DENIAL TO THE ZONING BOARD OF APPEALS

Date: December 9, 2022 1 10/23	
Applicant: Buzzetta / No OW Address: 73 Harding St, Blauvelt, NY	
RE: Application Made at: same	
Chapter 43, Table 3.12, Column 1 R-15 District, Column 2 Side Yard 20' w/ 13.1' proposed, Column 10 Total Side Yar Two variances required	
	*
Section: 69.15 Block: 2	Lot:17
Dear Buzzetta :	
Discoulation of the Delivery Description and	the sector of th
Please be advised that the Building Permit Application, wh	ich you submitted on
November 29, 2022, has been denied. I have enclosed a Xero	ox copy of your application, where you will find
at the bottom the reason for denial.	
In Accordance with Zoning, Chapter 43 Section 10.322	the time to appeal a determination of a
Building Inspector or Similar administrative office is the	
determination with the Town Clerk.	
The Clerk to the Zoning Board of Appeals, Debbie Arbolin	no, will assist you in the preparation necessary to
appear beføre the board.

BUZZETTA/NOLAN RESIDENCE
ONE-STORY ADDITION

73 HARDING STREET

PLOT PLAN

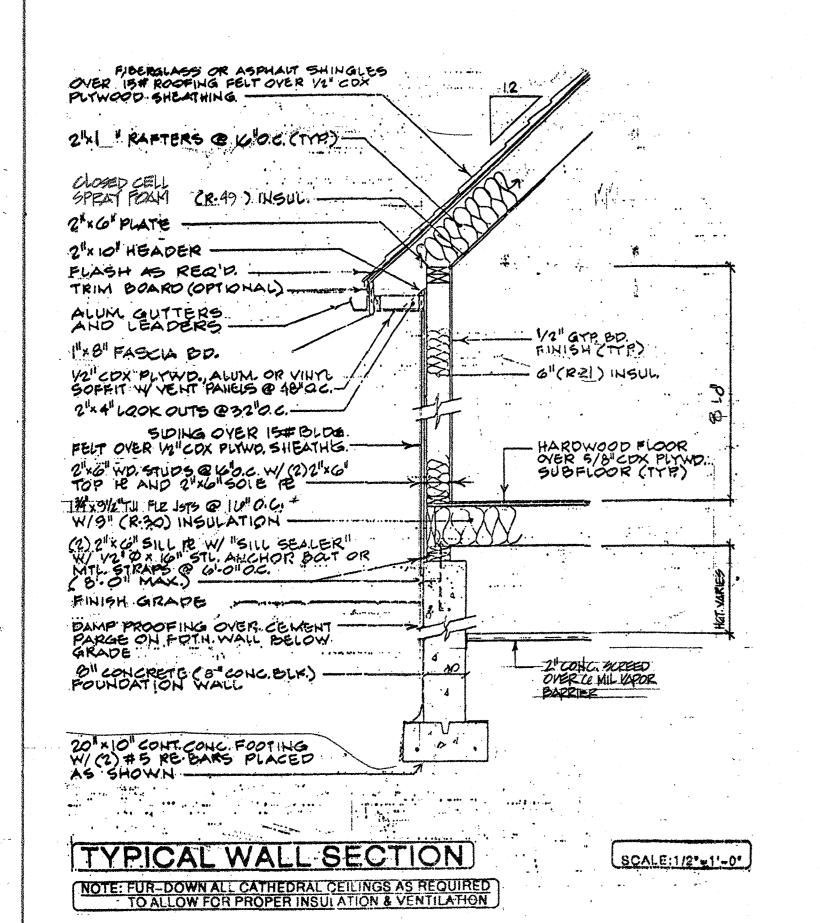
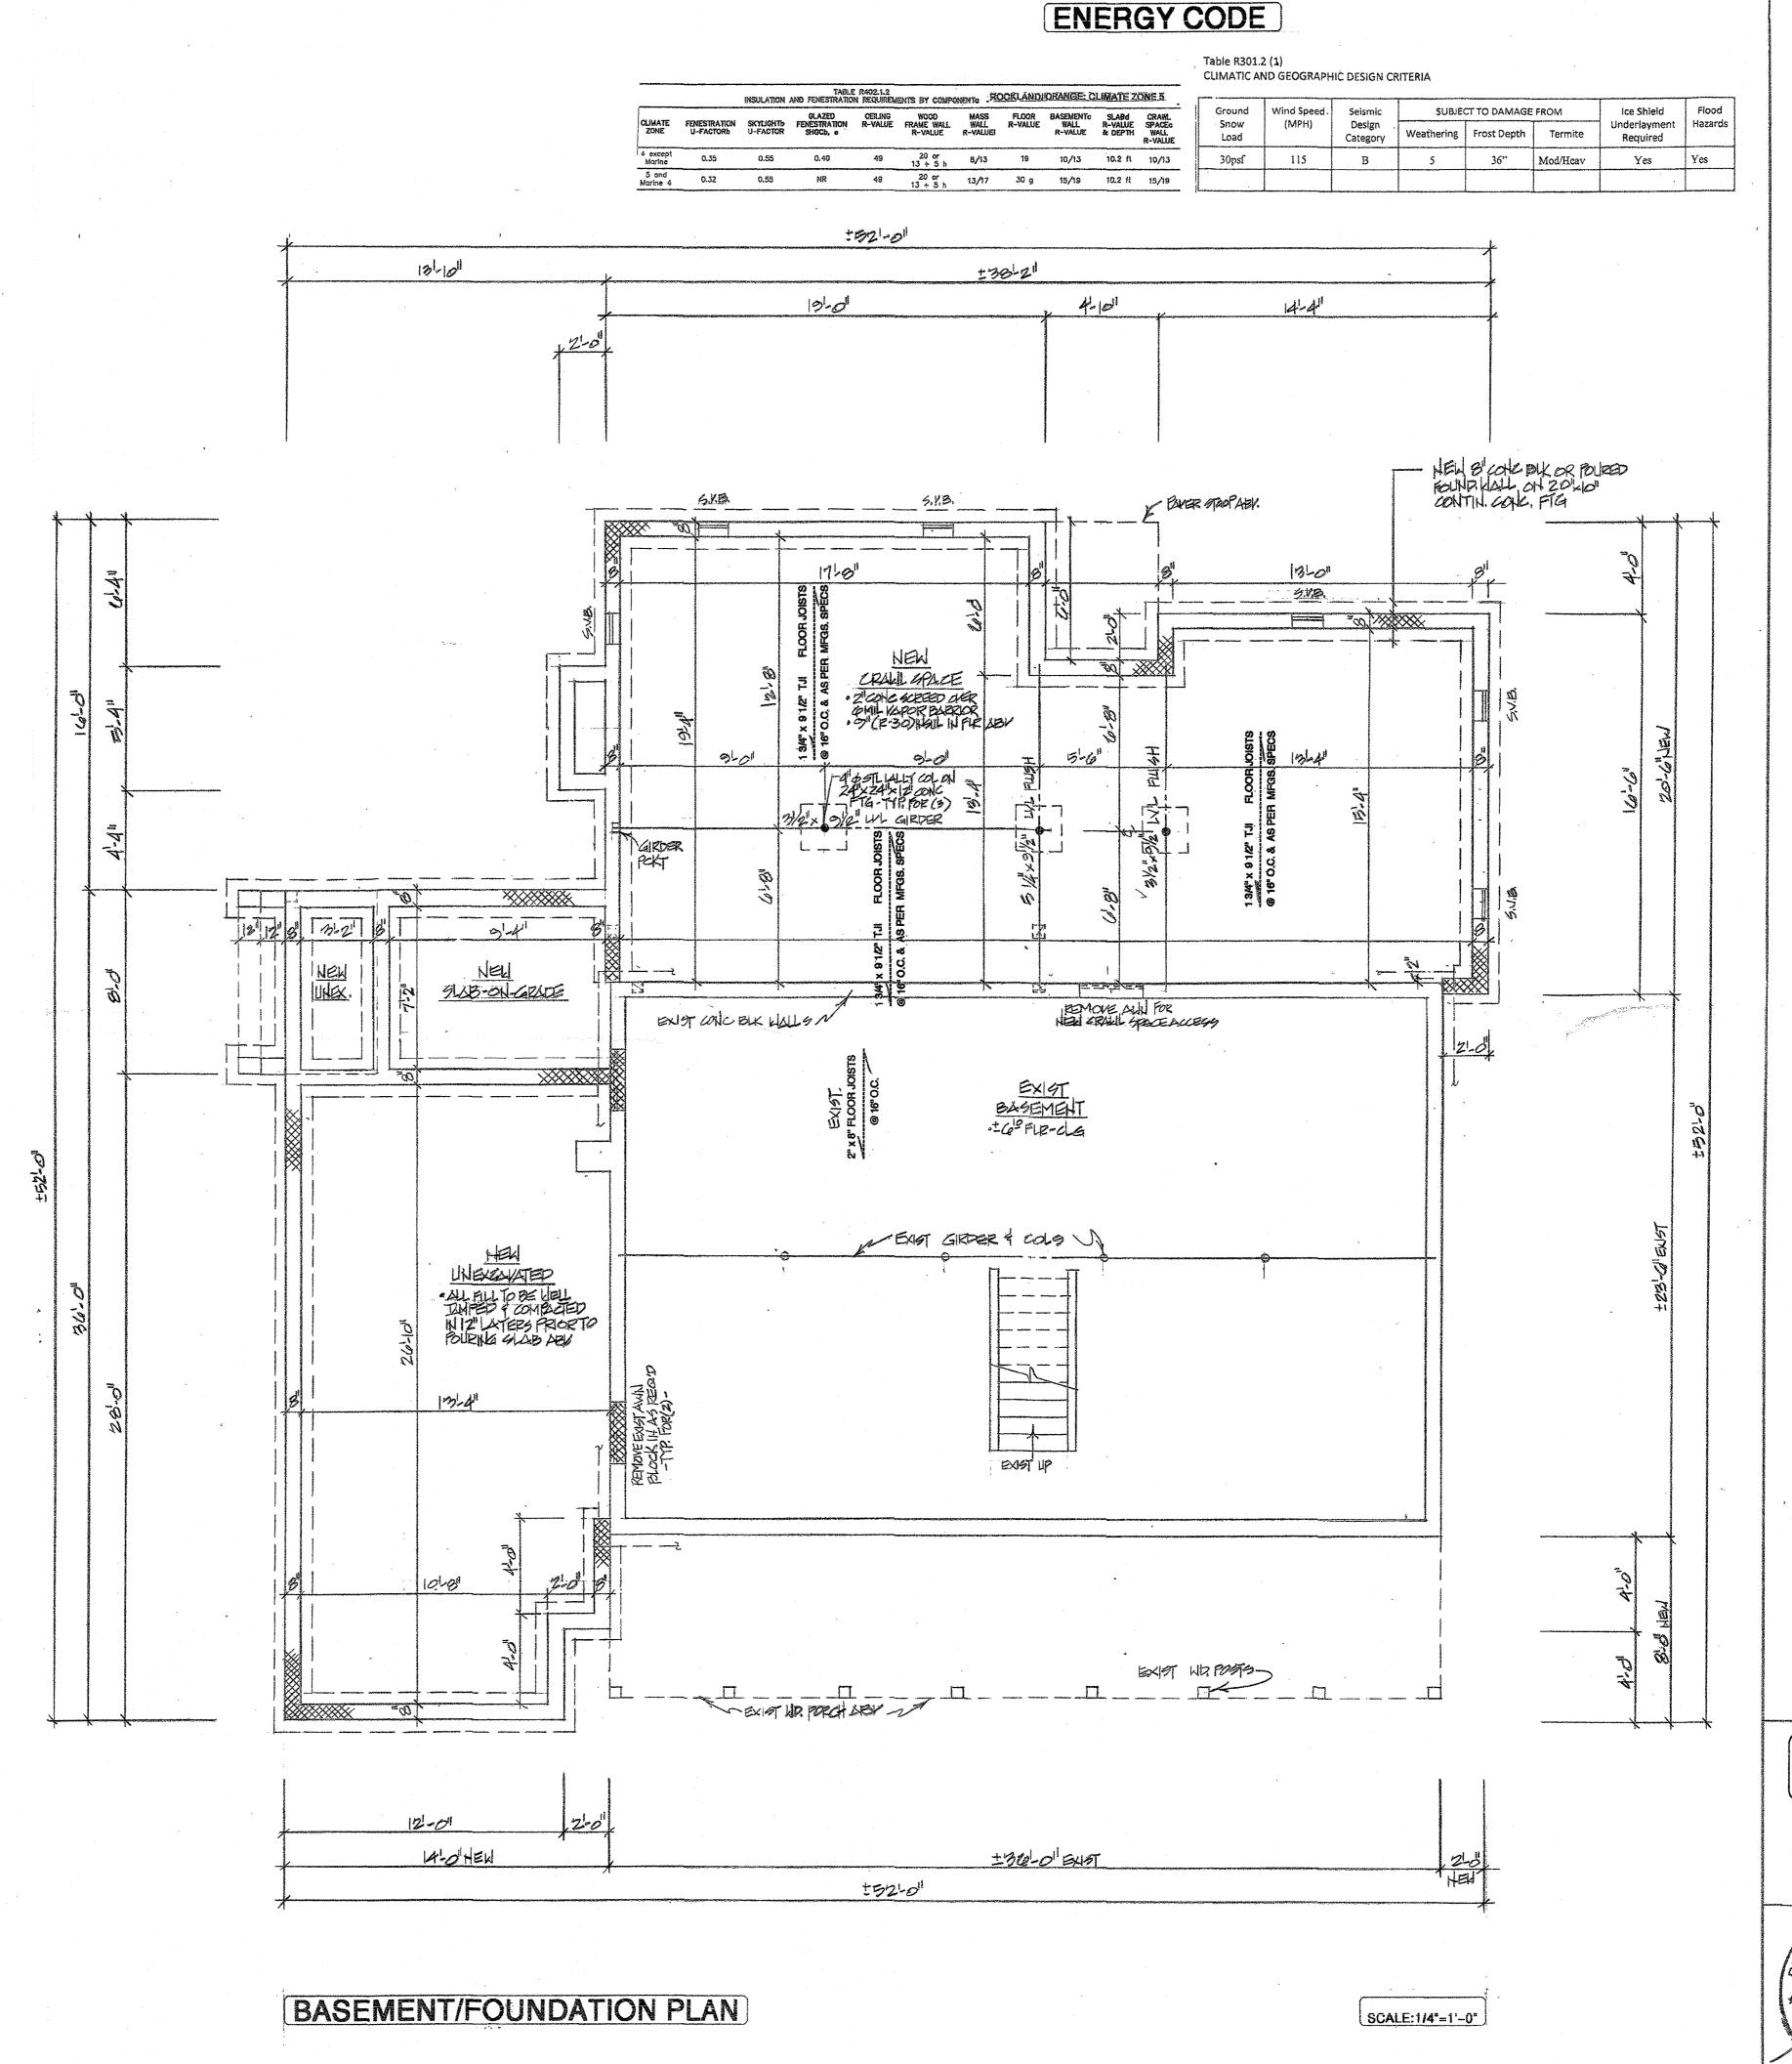
P	roposed Square Footage: 2,	III DING DEDA	RTMENT COMP			
_				La La I La C	, DELOW	30.
P	LANS REVIEWED:		,			
-	PERMIT REFERRED / DENIE	D.FOR:				
r	Chanter US. Cable 3.12	1 Column 1	= R-15 Austrict	Colum	m 2 > shoupm, ldumn	32SPK
	Poluma 9 Renured D	ide ward 20	W13.1' pup	Word.	Clym 10 Total Dick Yas	0/50

-	W) 47.9 perposed. 2	Variances,	regued.			
-		1	10/11/2			Page 1
	Ke penty, 19/2	8	12/14/0
